Lakeside Farms Elementary – ESS Relocatable

Bid #: 2024-03C

Lakeside Union Elementary School District

ADDENDUM 01

E-4.1

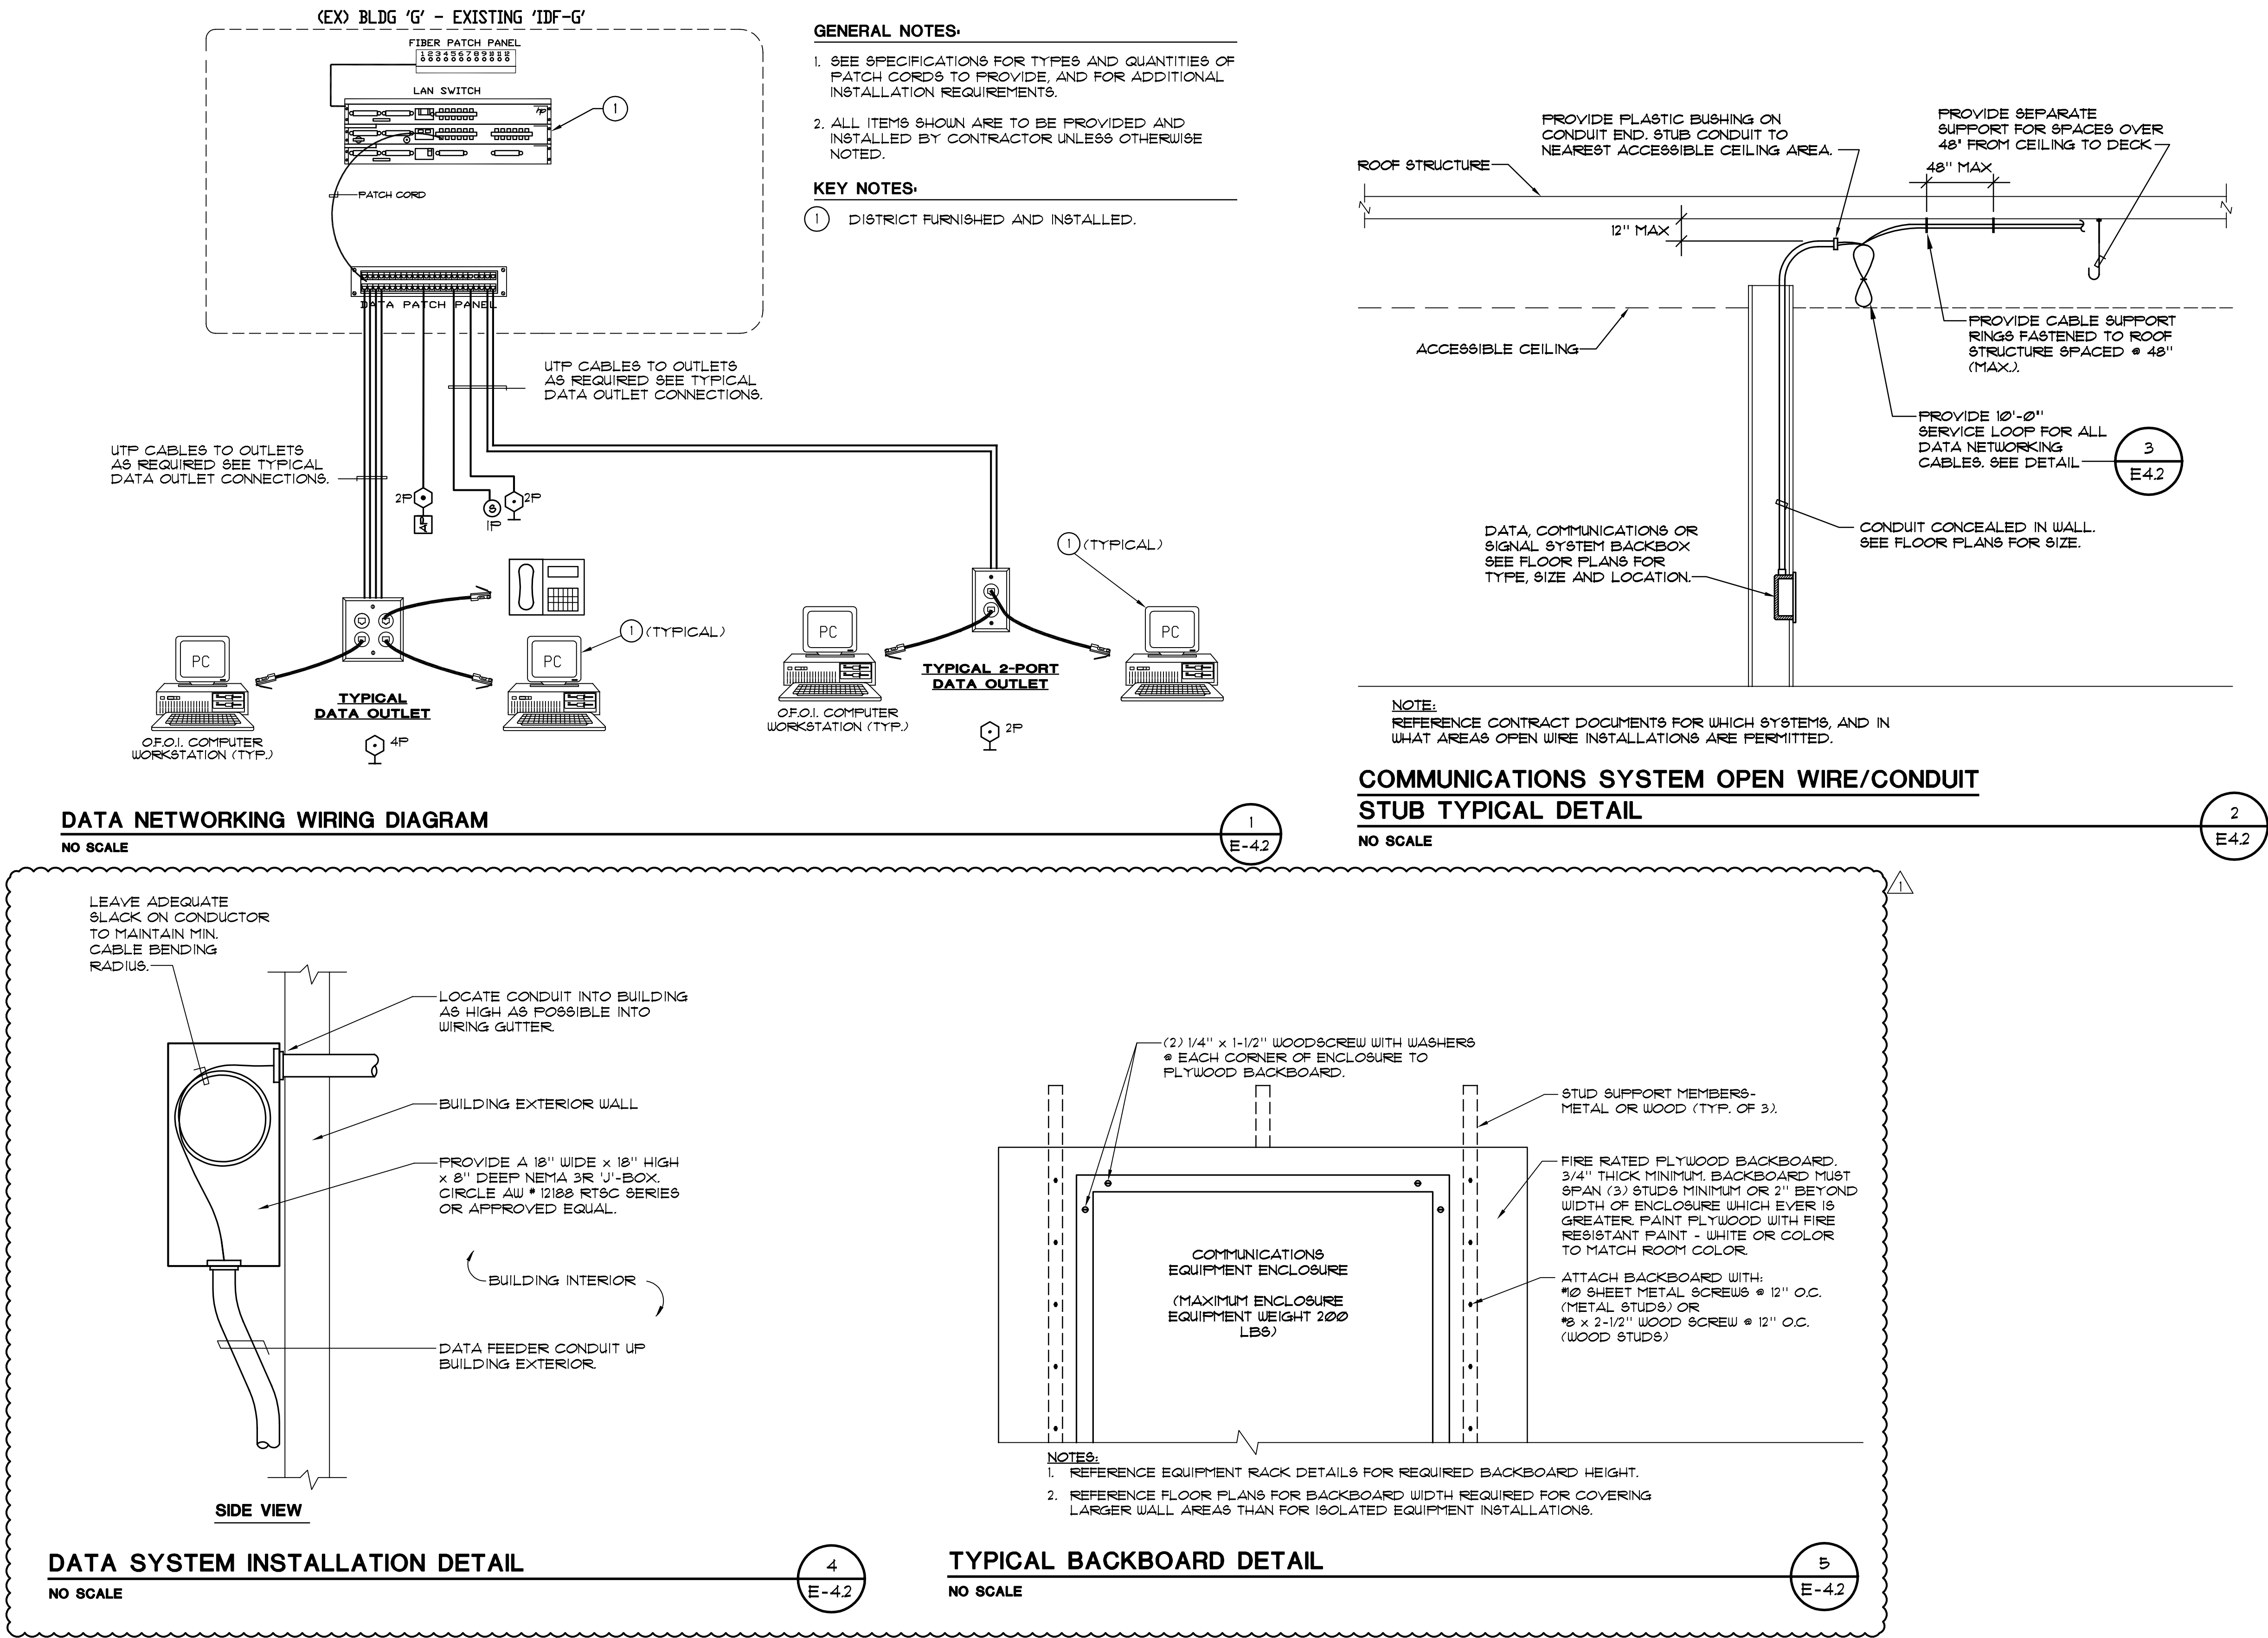
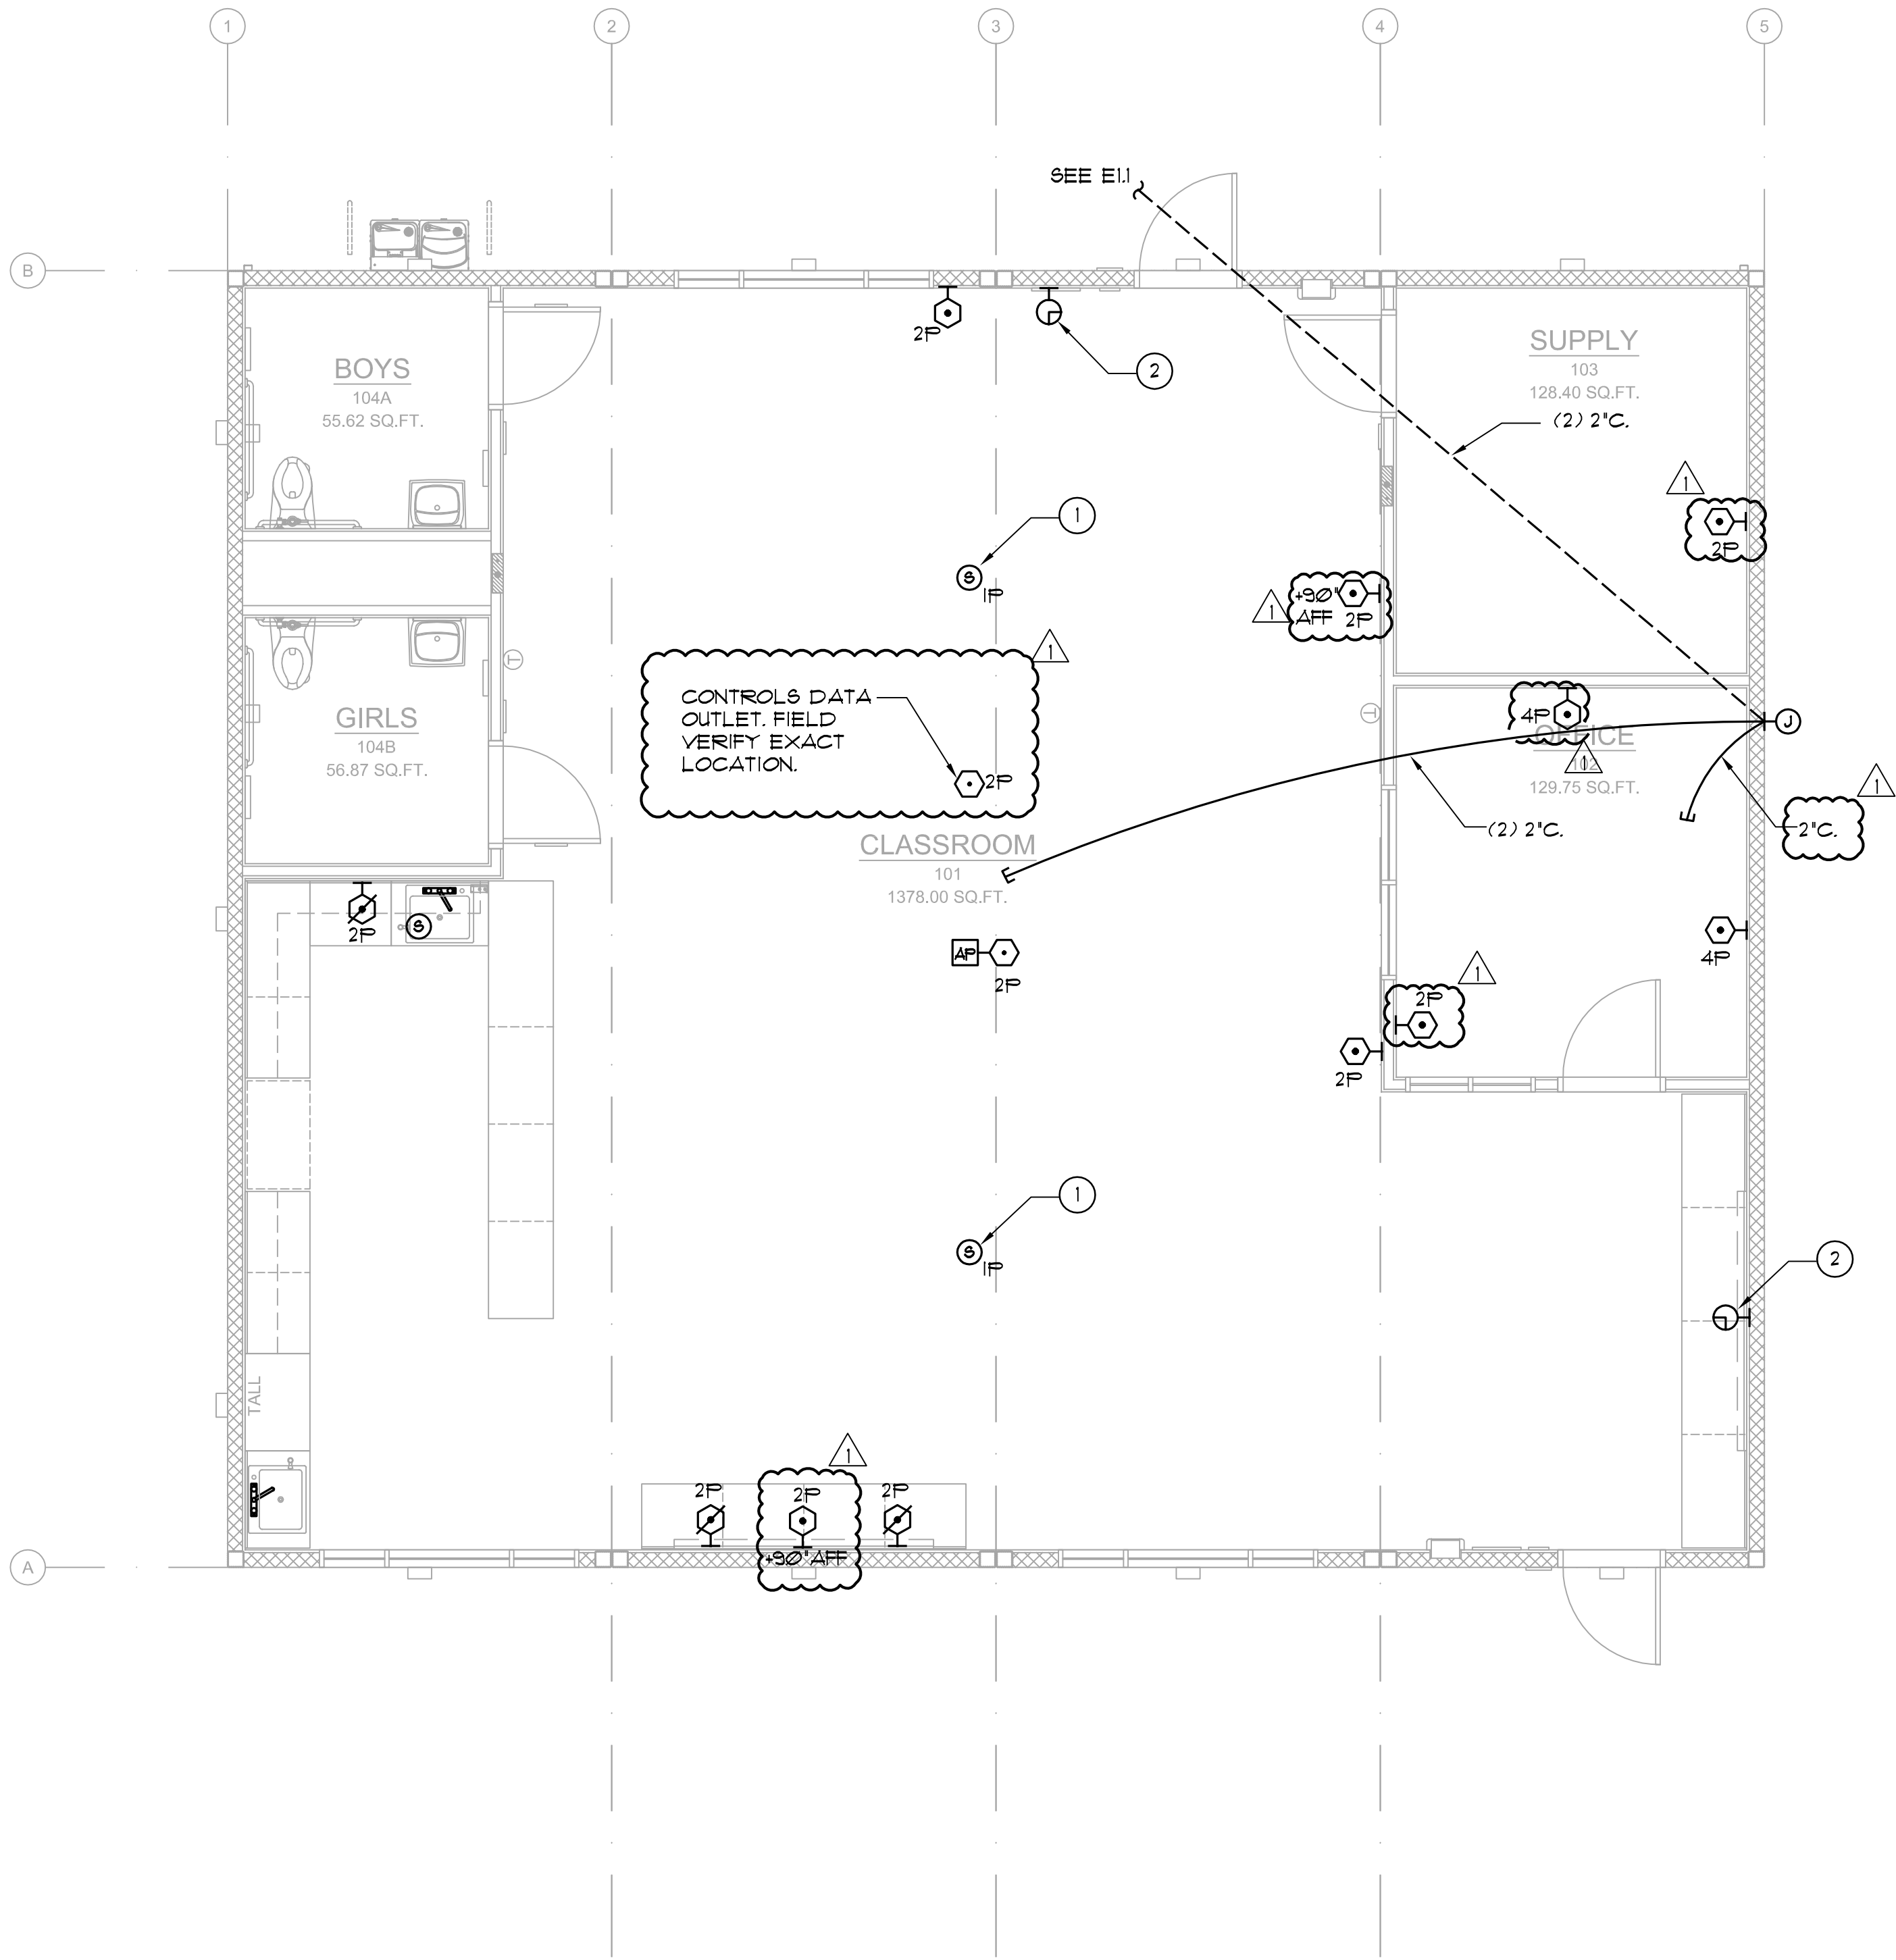
- Item #9. ADDITION – Floor Plan – Comm. E-4.1
 - a. Addition of data outlets to match AMS drawings.
- Item #10. ADDITION – Communication Details E-4.2
 - a. Added plywood background detail and junction box detail.
